Date: October 27, 2022

Subject: ADDENDUM #2

Project: Transition Building
(T99) Addition

Project No: 220082

E2.01

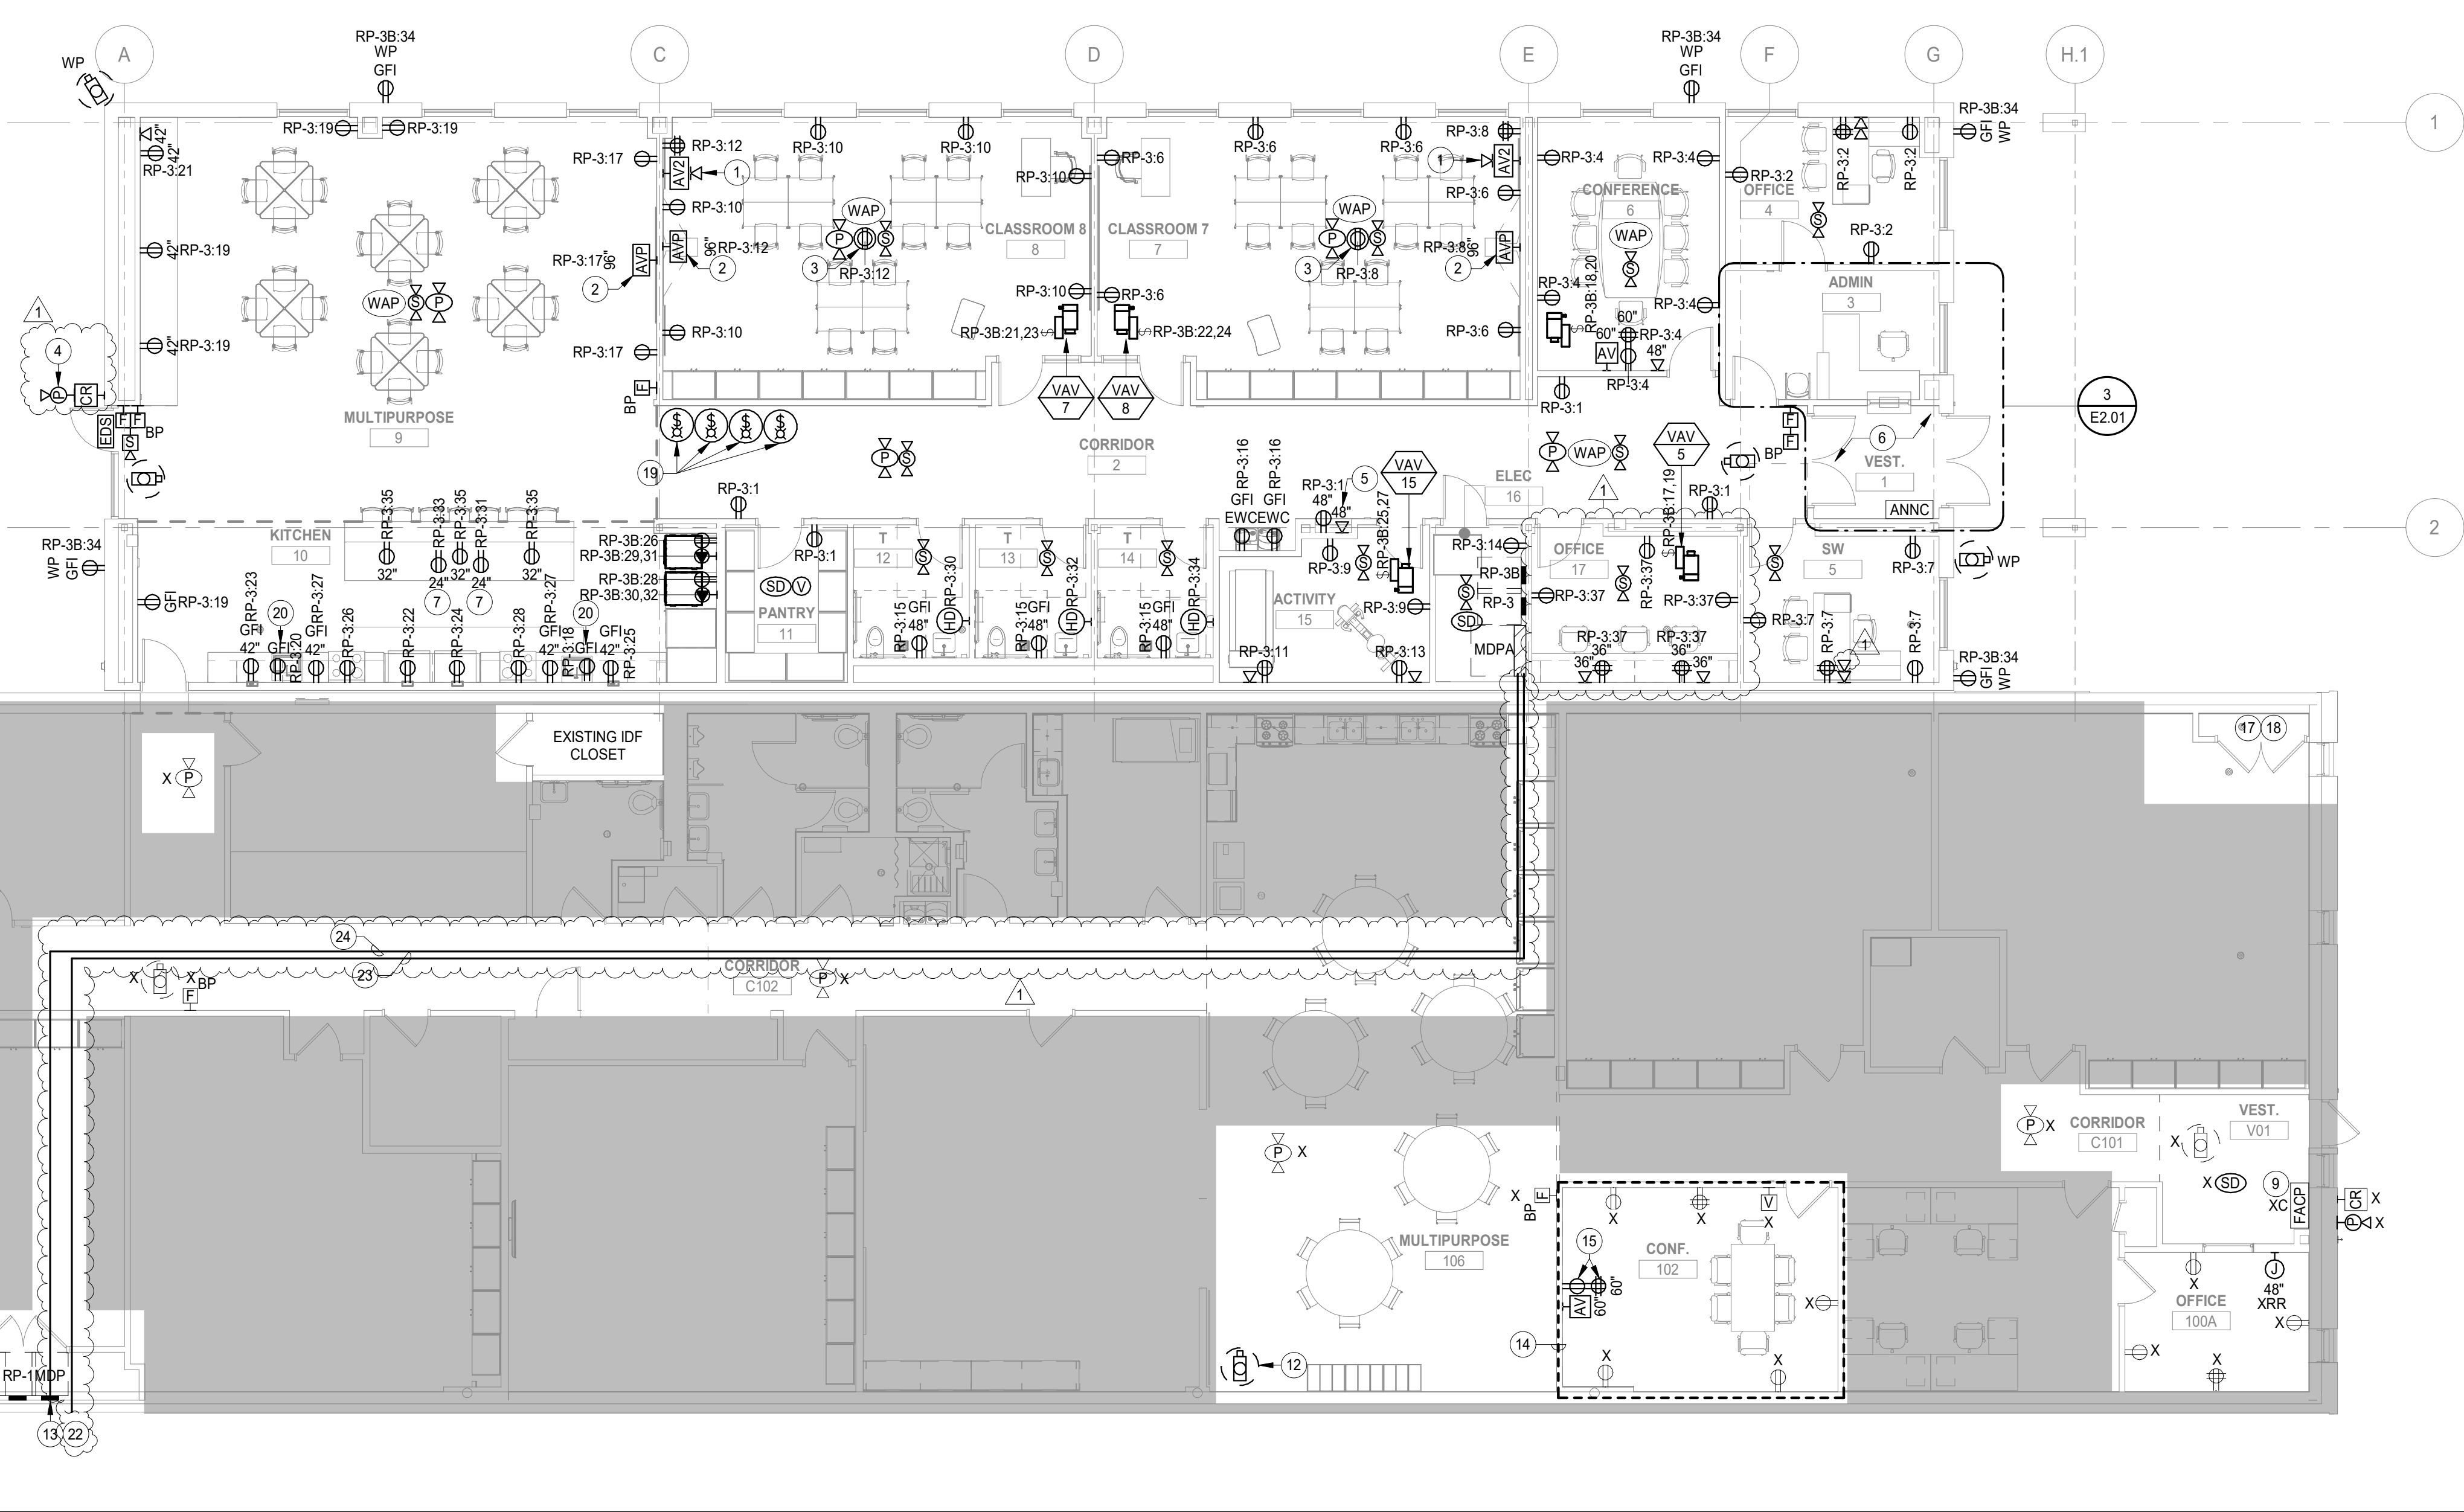
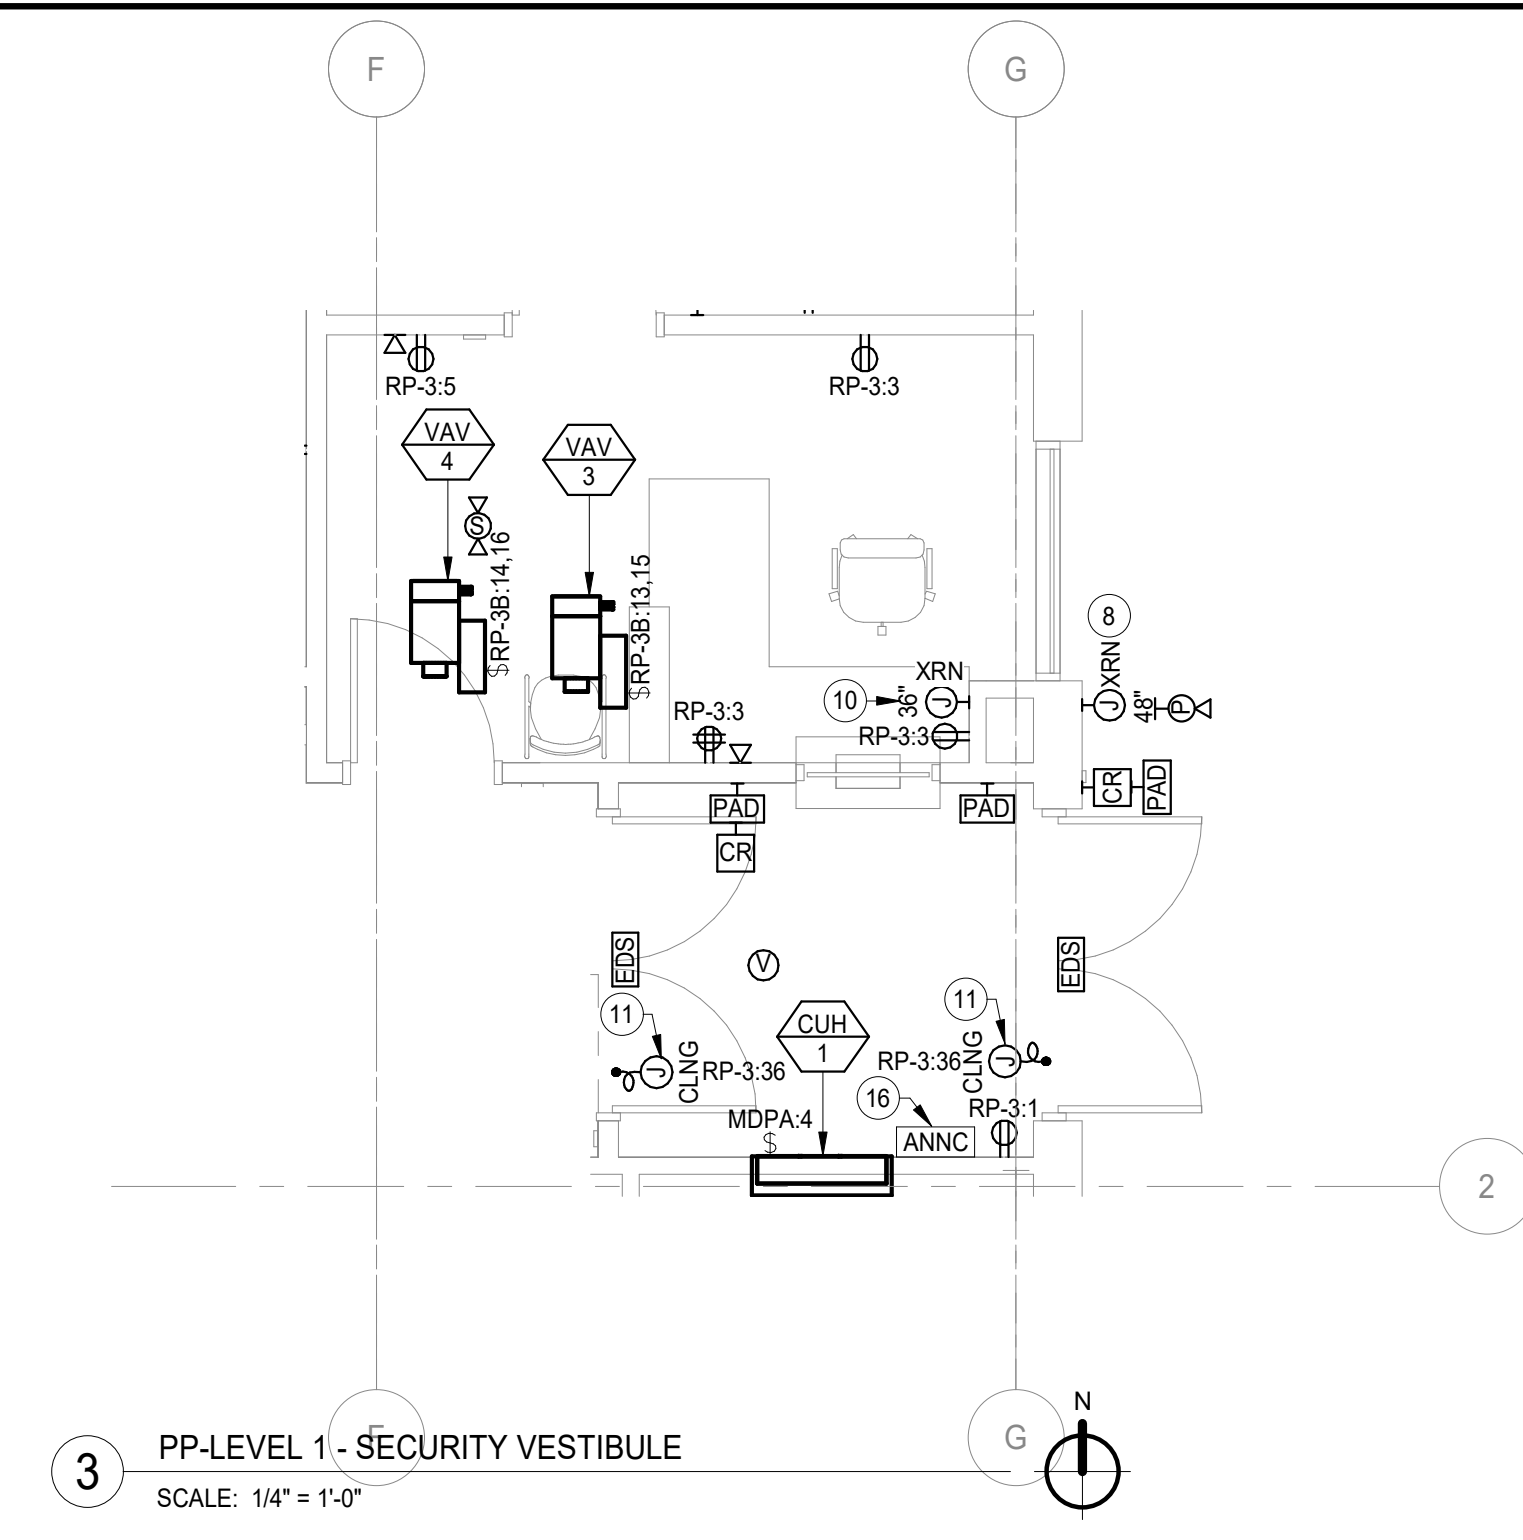
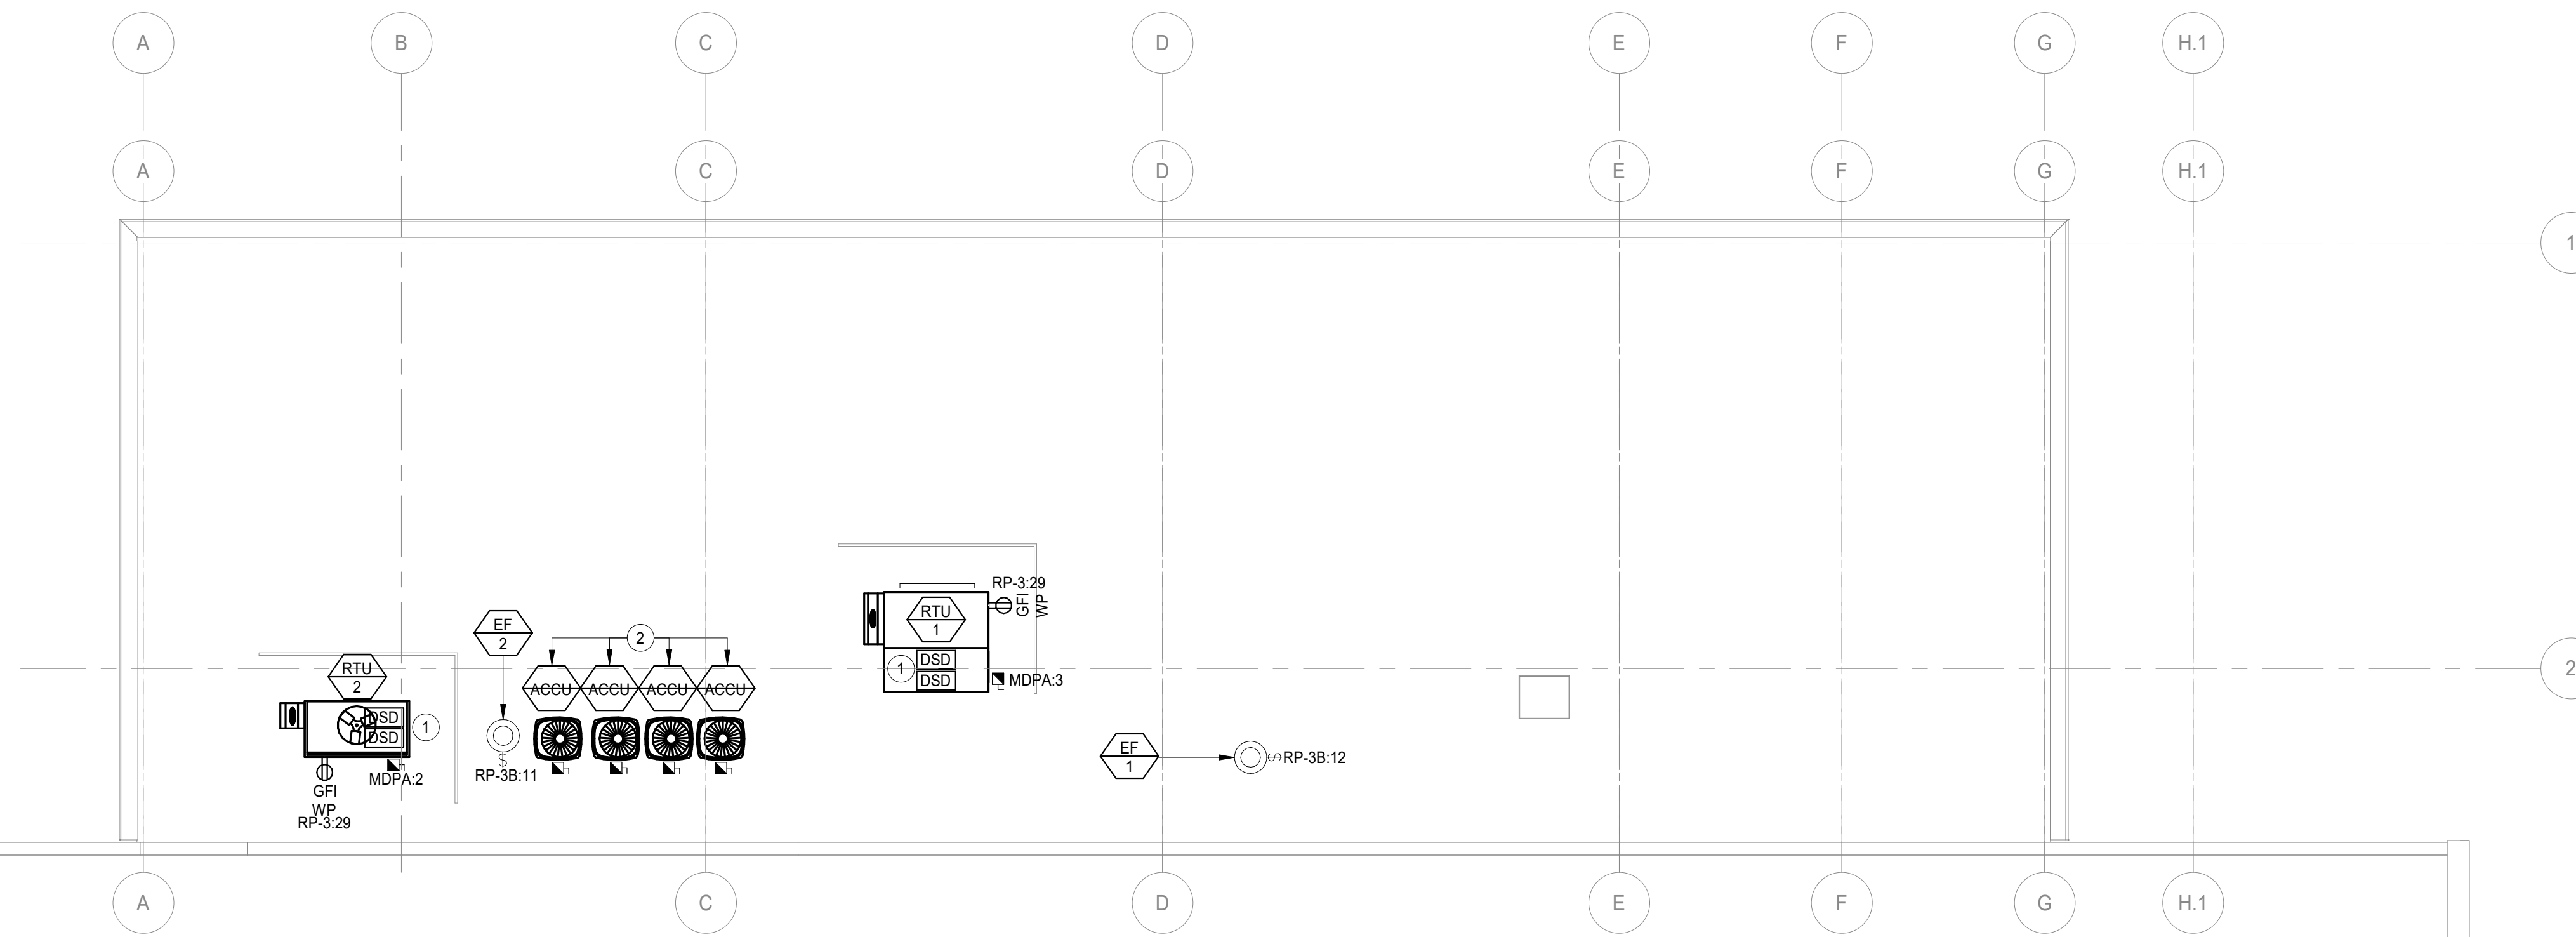
- Revised conduit routing to show approximate route of feeder conductors to and from panel MPDA and of the grounding Electrode Conductor for the concrete encased electrode.
- Existing panels added.
- Power and data added to room no 17.
- Card reader revised to new.
-

1 FIRST FLOOR POWER DEMOLITION PLAN
SCALE: 1/8" = 1'-0"

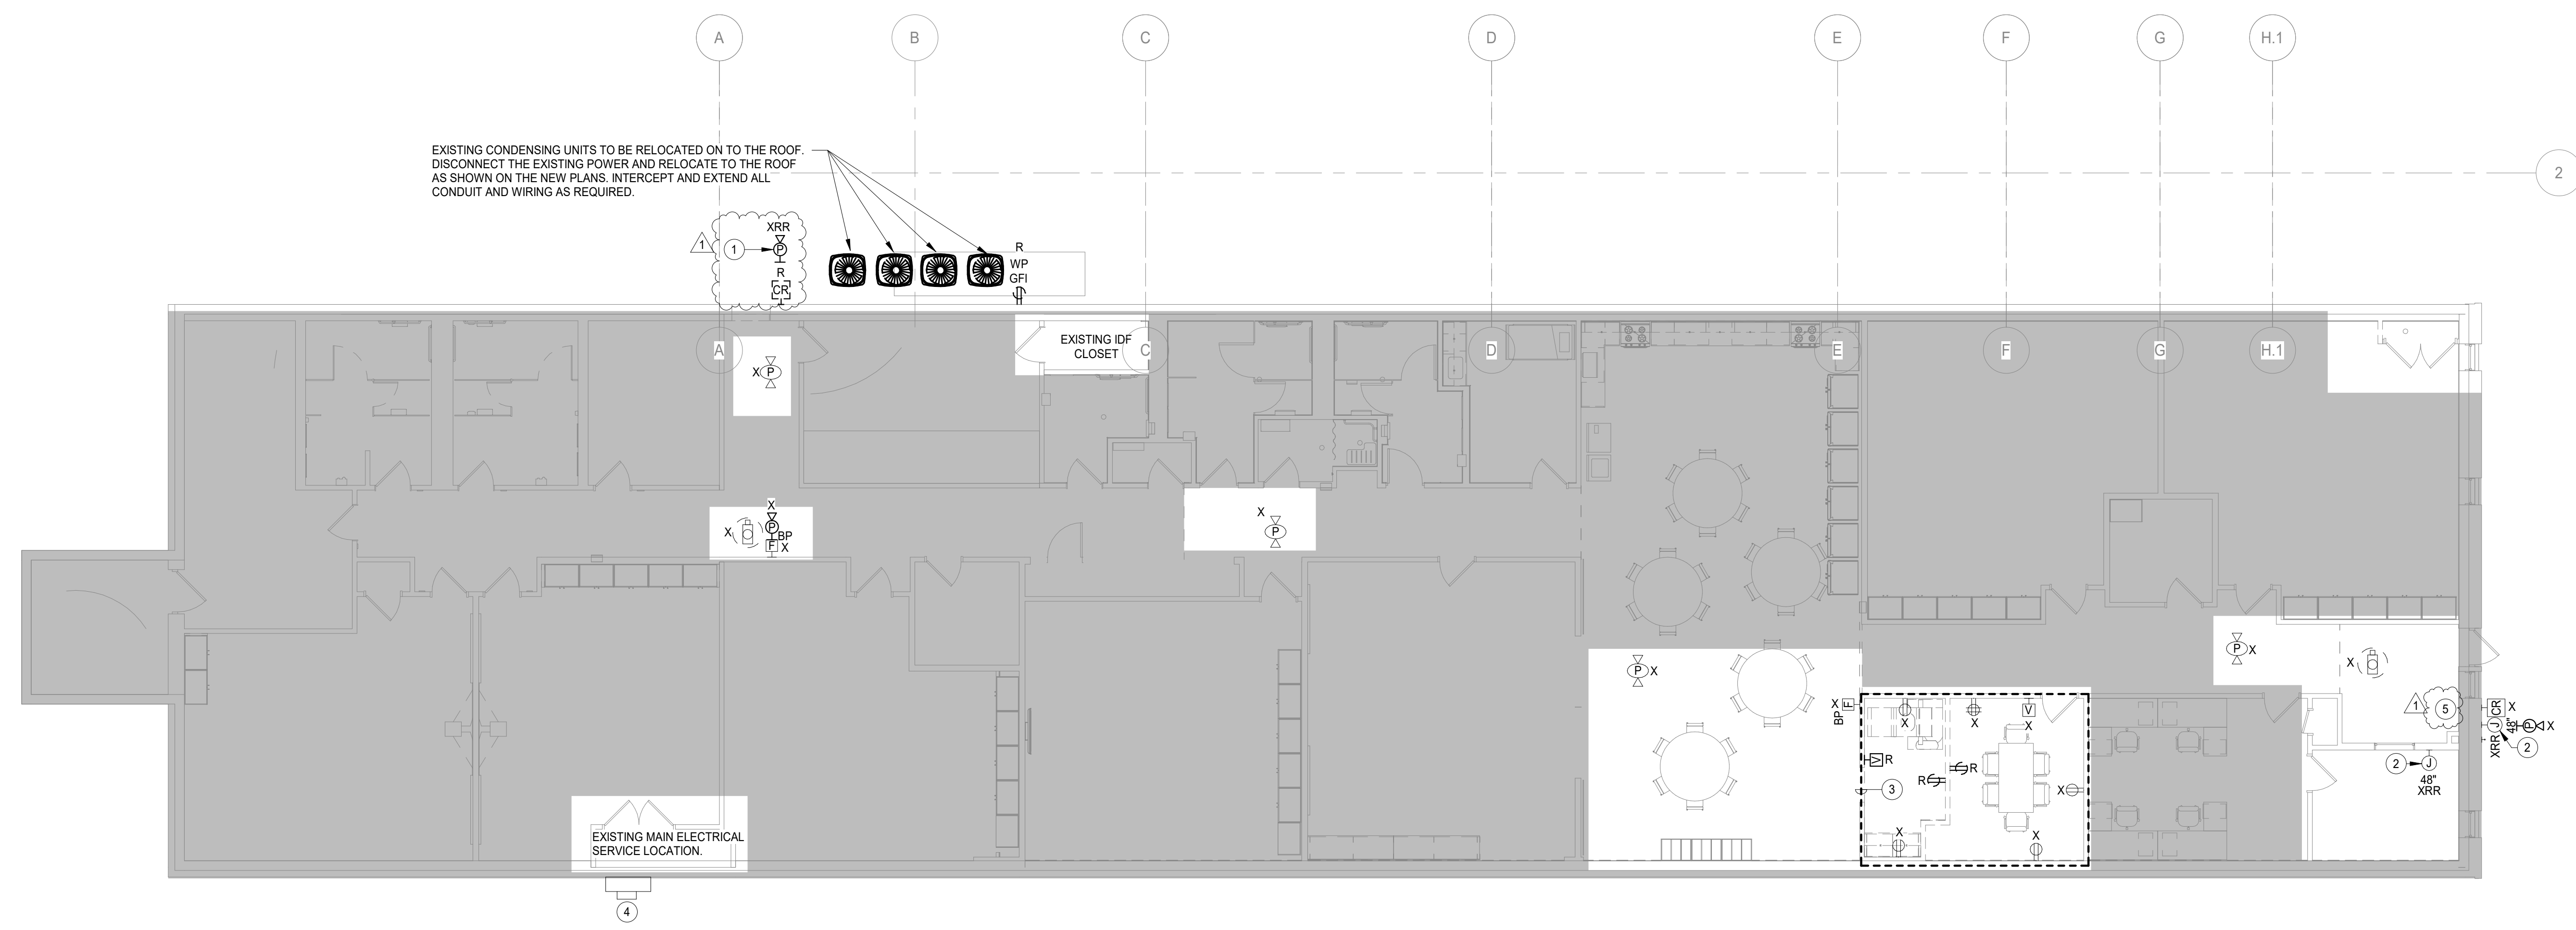
- Notes 1 and 5 revised.
